KITTERY TOWN PLANNING BOARD MEETING

AGENDA for Thursday, March 12, 2015

Pine Tree Plaza Site Plan – Modification to an Approved Plan

**KITTERY PLANNING BOARD
 FINDINGS OF FACT -
 for
 Pine Tree Plaza
 Modification to an Approved Site Plan**

Barrier Requirements for Embankment Heights

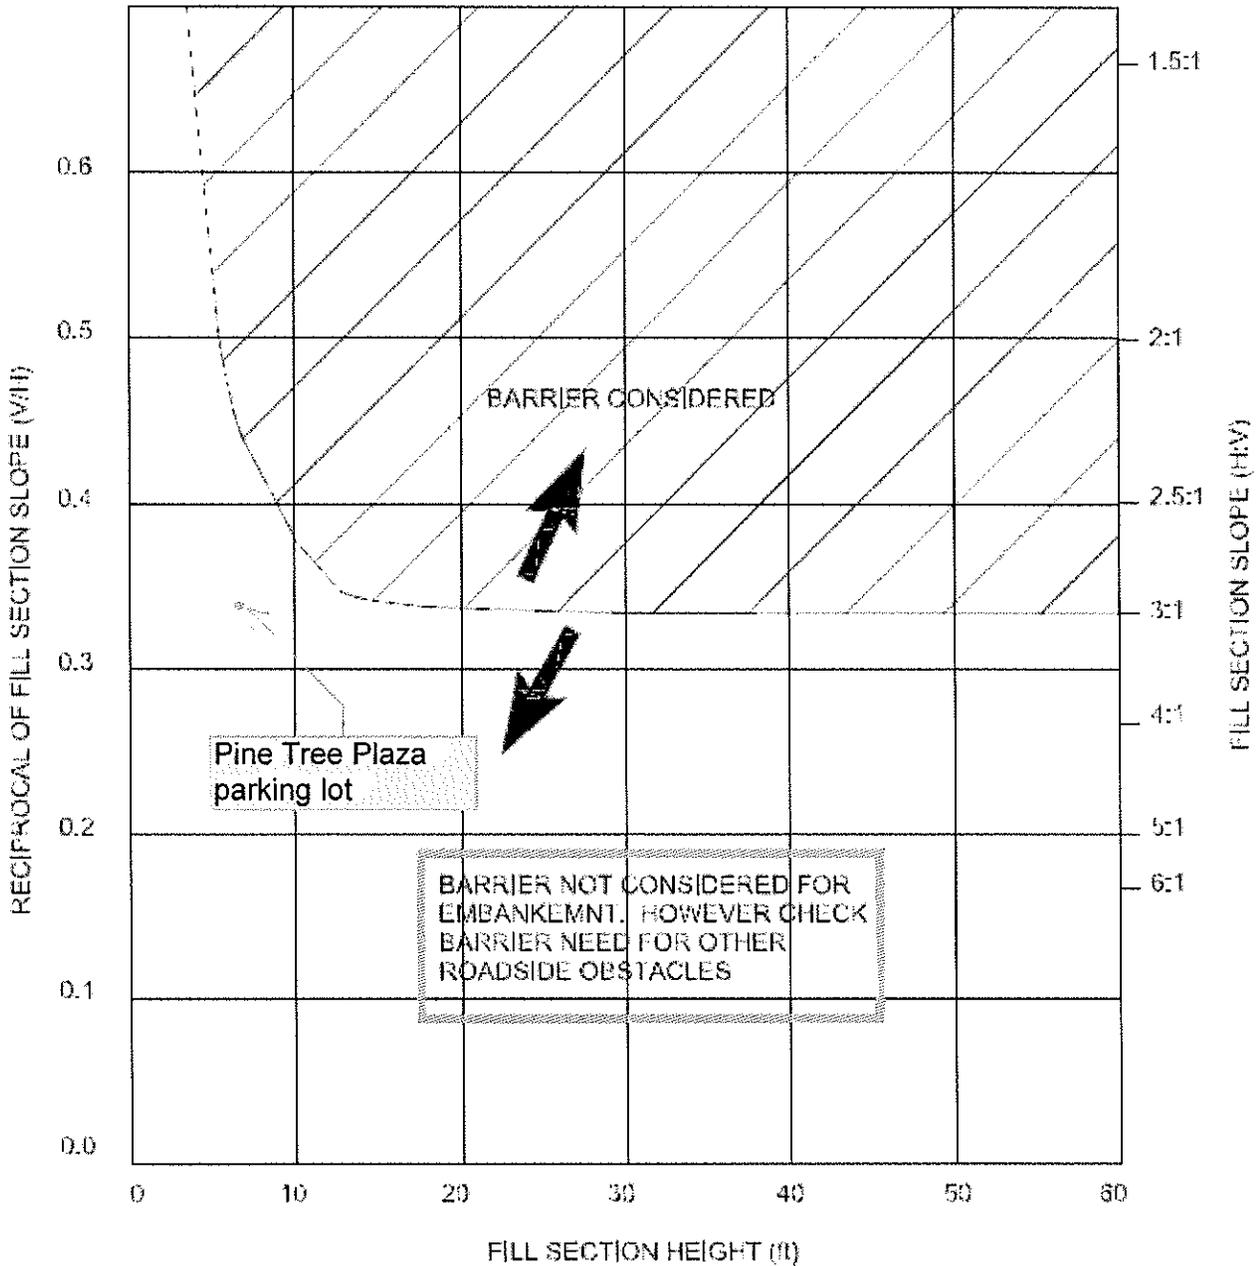
The only remaining comment is minor. We had previously suggested that a guardrail of some sort be installed at the border of the parking lot adjacent to the 3:1 slope heading down 6-7 feet to the rain garden. We raise this as a general safety issue that would prevent cars from inadvertently heading off the parking and down that slope under certain conditions or driver inattention. The applicant indicates they wish to use the area as snow storage, and not have a barrier, which is understandable. Altus has included AASHTO guidance on roadway design in support of that. (The guidance applies to roads design, not parking lots per se). I have retained the suggestion that the applicant consider wheel stops or some other measure that would be a barrier for cars, and not interfere with snow storage.

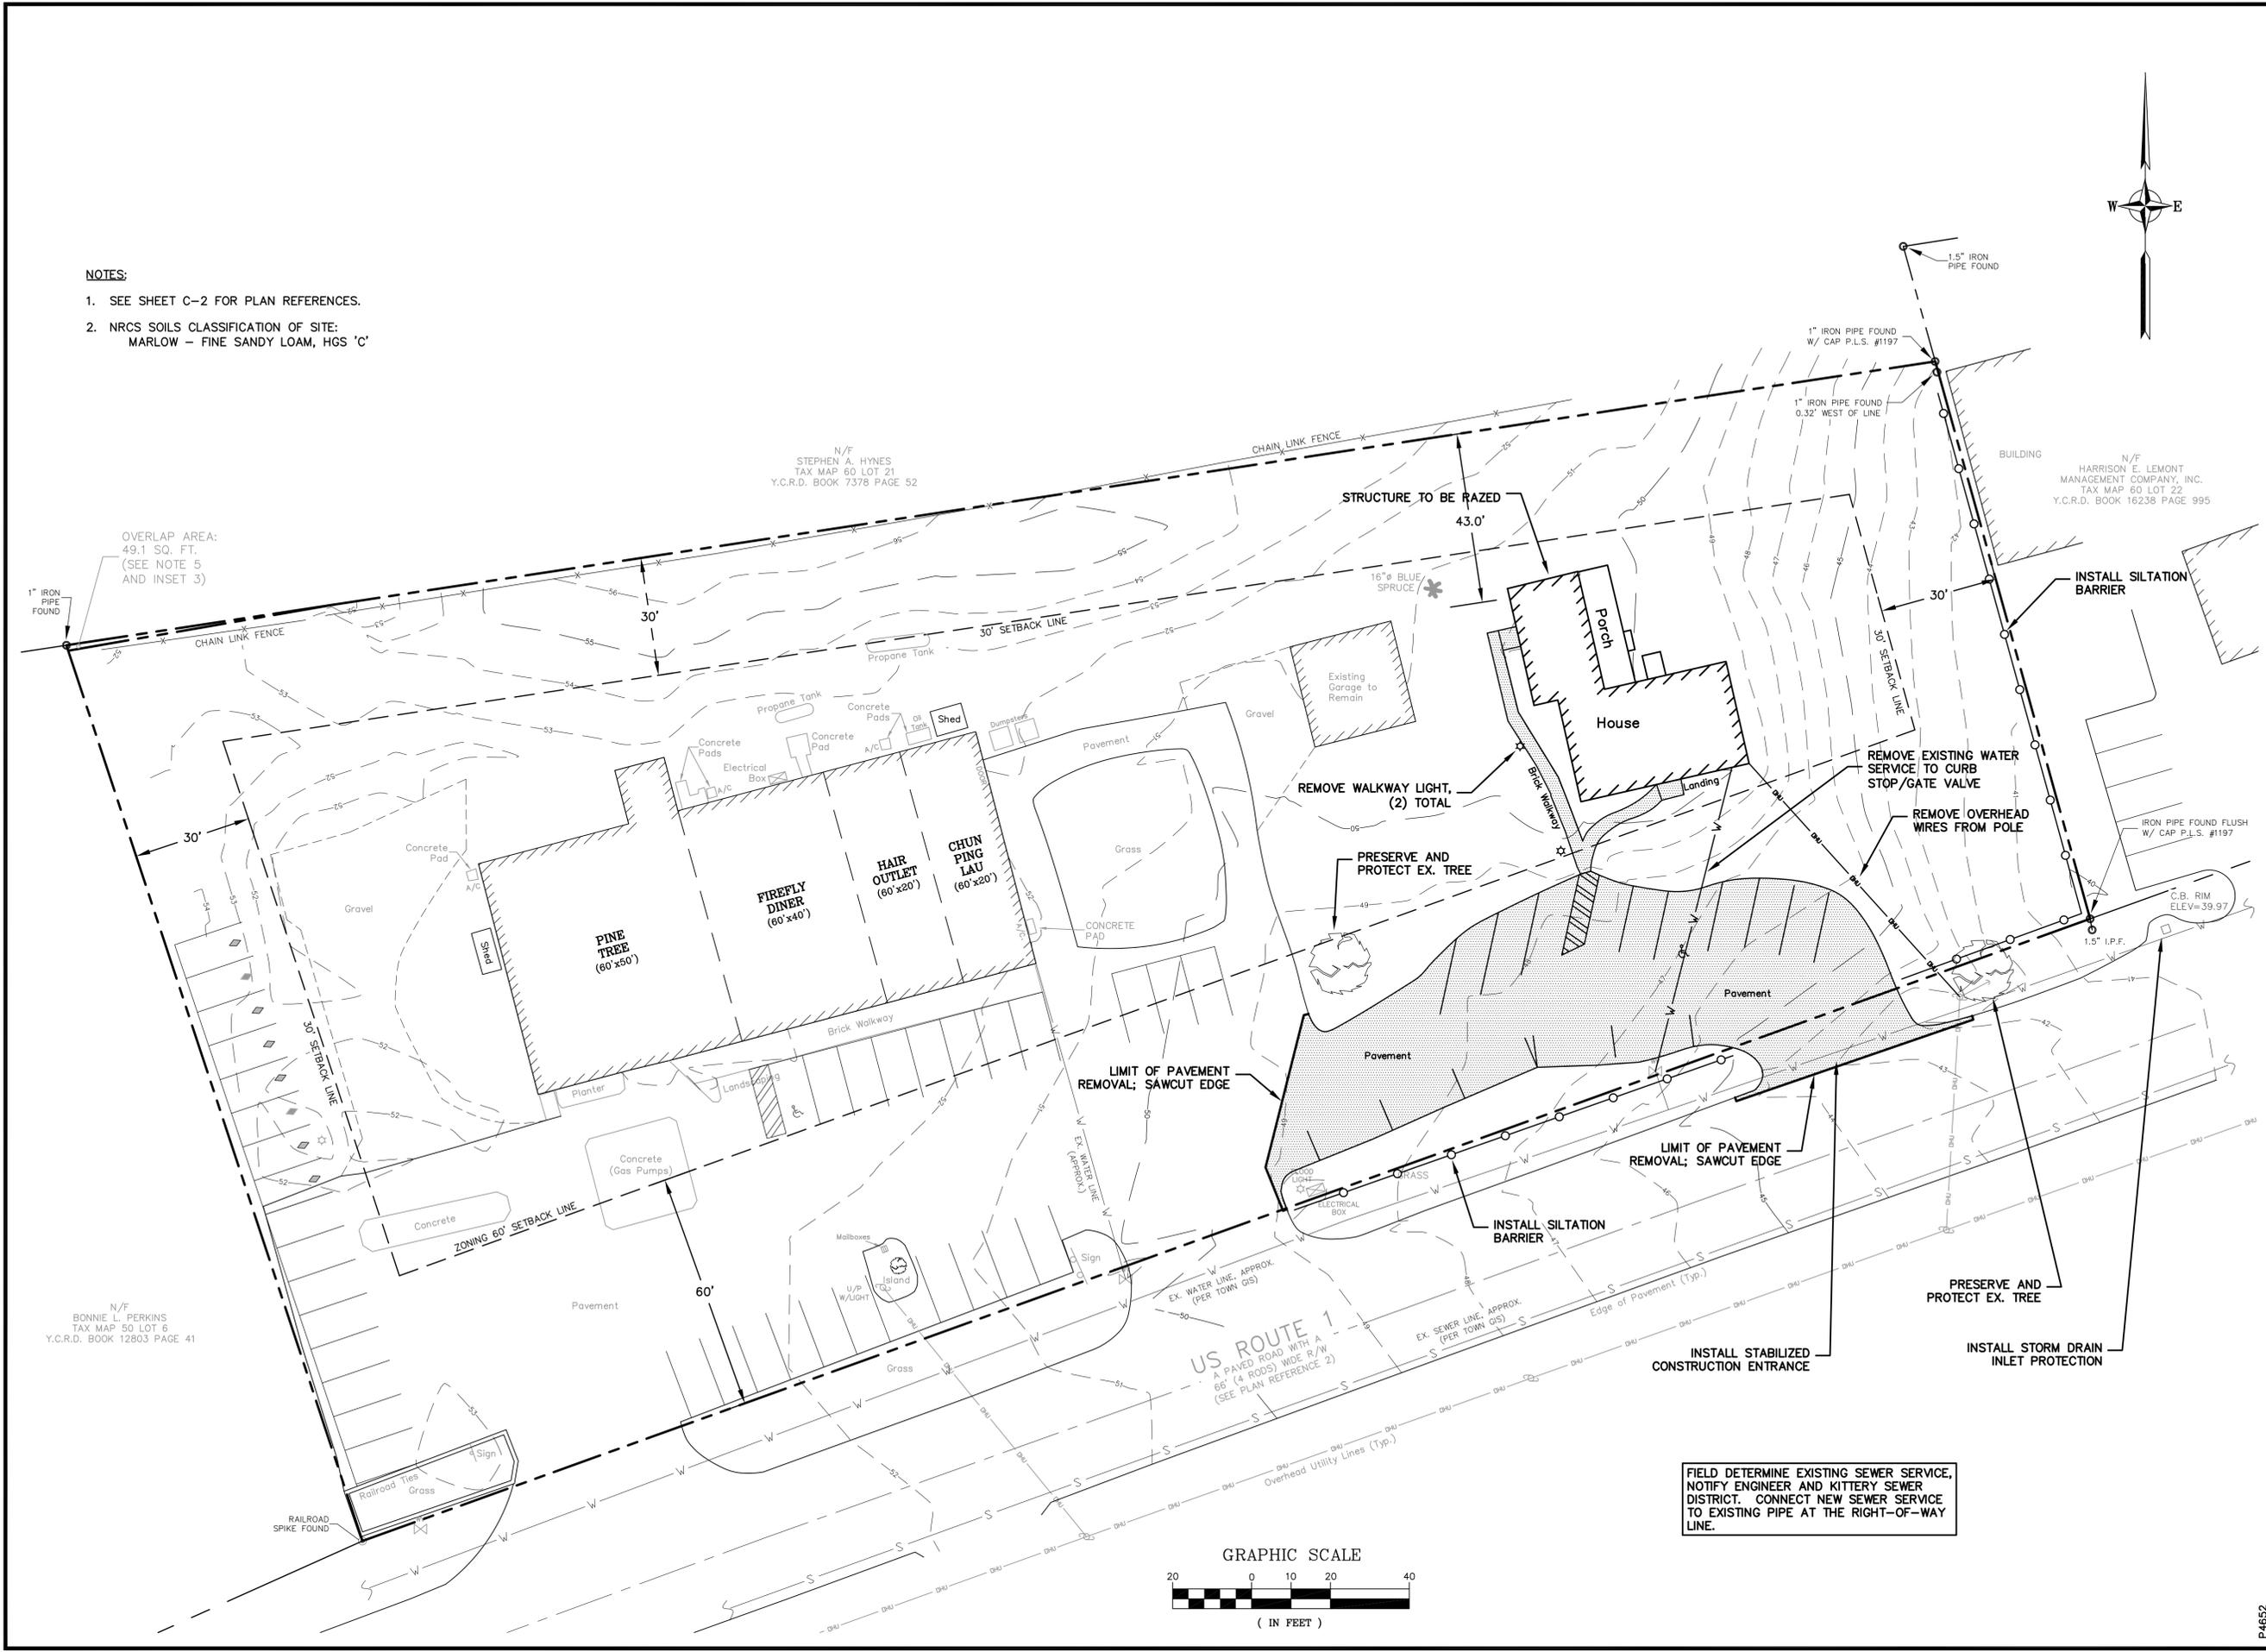
- 1) 16.3.2.13. D.4 Location and Screening of Parking. There is a clear expectation for parking along Route 1 in the Mixed-Use Zone to be screened from view. The Site Plan shows plantings that straddle the front property line, however, more information is needed to adequately determine if the proposed screen will be effective throughout the year.

- 2) 16.3.2.13. D.6 Landscape Standards. All new and modified development along Route 1 in the Mixed-Use Zone is required to have a 'Landscape Planter Strip' along the front of the property with an average depth of 50 feet, a maximum of 70 and minimum of 30 feet. The area is to include groundcover, perennials, shrubs, and trees and designed to provide an aesthetic screening. The Design Handbook calls for plantings to be a 3-1/2-foot high minimum. There may be instances due to sight lines that plantings need to be no higher than 3-1/2 feet, otherwise the landscaping should be a mix of plants that will provide year-round screening while accommodating a view of the buildings on the site.

To compensate for the lack of planting depth and to aid in achieving the screening objective, Staff recommends having the striped area located to the right of the building and adjacent to the front row of parking designed as a planted island. Ideally this would include one of the front parking spaces to the left of this area. Though planted islands present difficulty in plowing, the code and the Design Handbook anticipates such islands in parking lots. (16.8.9.4.G. and Landscaping III-9)

- 3) Staff recommends, as a condition of approval, the plan be revised to include more specifics on plant species and size for the proposed trees and shrubs in addition to the planted island and supplementary plants mentioned above.

- 4) Minor Plan changes:
 - a) The light poles should be added to the legend (G-1) and the pole model and height noted on the plan (C-2).
 - b) Will the large re-graded area associated with the proposed drainage soil filter be maintained as lawn or wildflower meadow? The type of vegetation should be denoted on the site plan (C-2).

- c) The caliper size of 2-1/2 inches for proposed street trees and height of 8-10 feet for proposed evergreen trees needs to be noted on the site plan (C-2), in addition to the species name

- d) Location of shrubs, species and size should be noted on the plan.
 - e) Amend existing note on site plan (C-2) that refers to plantings being maintained at “a maximum height of 3-1/2 feet” to read: “Plantings inside the public Right-Of-Way to be maintained...”

5. Revise the site plan (C-2) to reflect the minor plan changes staff recommended in the 3-12-15 Plan Review Notes.
6. Revise the site plan (C-2) to include a planted island in place of the striped area located to the right of the building and adjacent to the front row of parking. The design of the island to include the adjacent parking space located in the front of the proposed building.
7. Revise the site plan (C-2) to include additional tall shrubs and small trees in the area adjacent to the
